**Subject:** Environmental Protection Agency (EPA) Safe Drinking Water Act Compliance  
Inspection Report.

**Follow-Up Site Visit Conducted by Virginia Department of Health-Office of  
Drinking Water's (VDH-ODW) Richmond Field Office**

The City of Richmond (COR) owns and operates a public waterworks (PWSID 4760100). The system is served by a Class 1 surface water treatment plant with a permitted capacity of 132 million gallons per day (MGD).

Figure 79. General Housekeeping Observation (VDH)

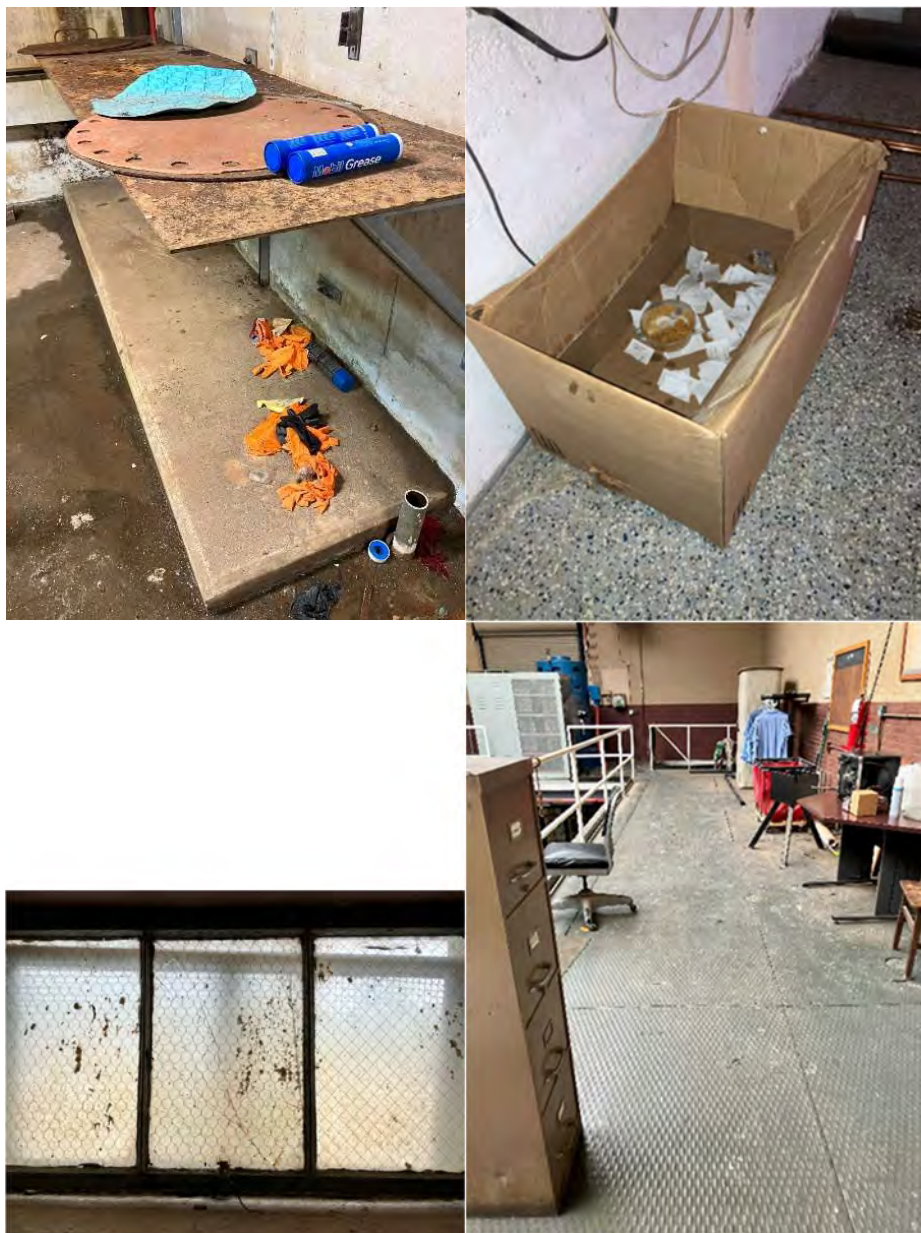
A general lack of housekeeping was observed with dust, trash, and standing areas of water throughout the water treatment plant and distribution system (Figure 59, Figure 79). As new equipment is installed and upgrades occur for infrastructure, COR must properly maintain new equipment to the end of its useful life.
